PROJECT: Huntbridge Shopping Center - New Comm. Pads

CITY OF LAS VEGAS		DATE:
INTER-OFFICE MEMORANDUM		May 29, 2018
TO: Land Development Services Department of Building & Safety		FROM: Albert Sung, P.E. Flood Control Project Engineer Department of Public Works
SUBJECT:	Drainage Study for:	COPIES TO:
	Huntridge Shopping Center – New Commercial Pads	Lochsa Engineering
Cross Streets:	SWC Maryland Pkwy & Charleston Blvd	Ten 15 Huntridge LLC
File Number:	F:\Depot\DSMemos\DS4985A.doc	Bart Anderson, P.E., DevCo
Parcel Number:	162-03-513-008	CCRFCD
Zoning Action:	SDR-72792, VAR-72791	
FEMA Flood Zone	YES NO X	
Proposed Storm Drain	YES NO X

Technical Drainage Study for Huntridge Shopping Center New Commercial Pads

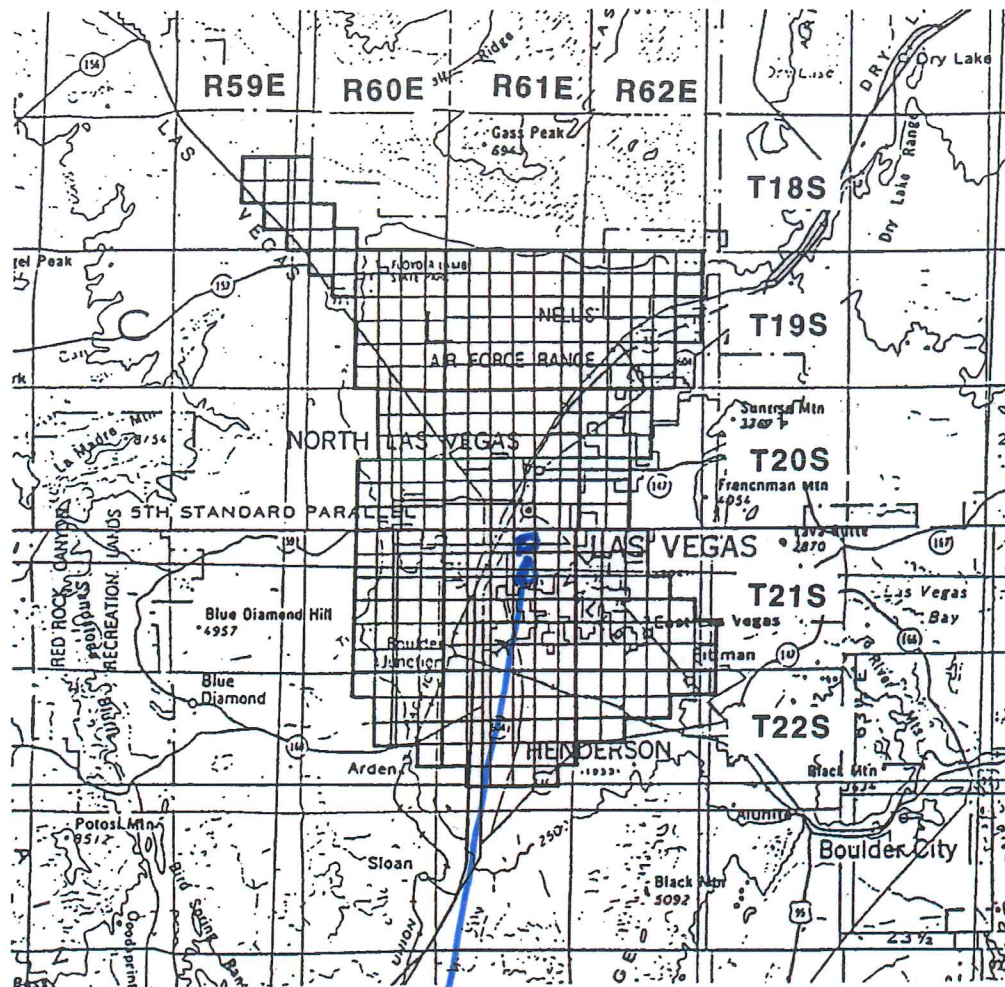
1. Add calculation results for hydraulic cross-section 2 to Appendix B of report.
2. Add existing storm drain facilities in perimeter streets to improvement plans.
3. 10-year, 6-hour Street Flow Summary table on sheet DR1 incorrectly reports dry lane width as 45.19 feet. Revise to reflect actual dry lane width.
